Request for Interpretation No. 22

AC Class Rule Version 1.4: December 8<sup>th</sup> 2015

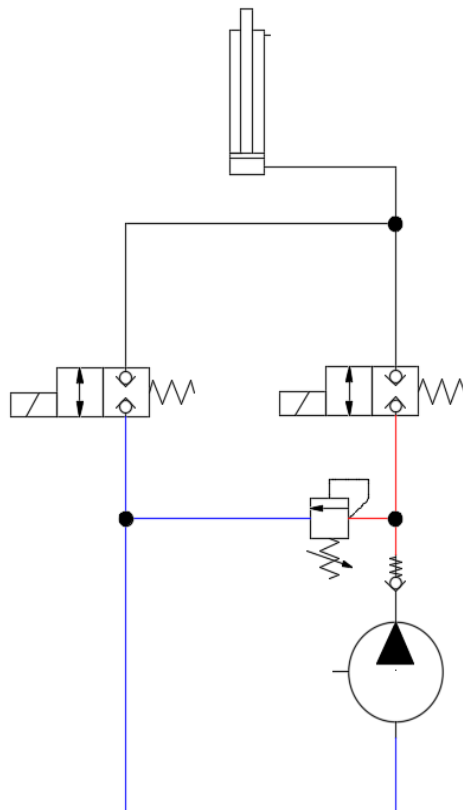
1. Is it permissible for the pressure inside a hydraulic cylinder to exceed 350 Bar due to application of external force to the cylinder (as may occur in the circuit below)?

Relief valve set to <350 Bar

2. Is it permissible to use this circuit if it is shown by calculation that cylinder pressure will not exceed 350 Bar under all applied load cases?
-

1. No.
2. No.

Note: Any required relief valves must be sized such that pressure does not exceed 350 bar in the face of maximum flow.
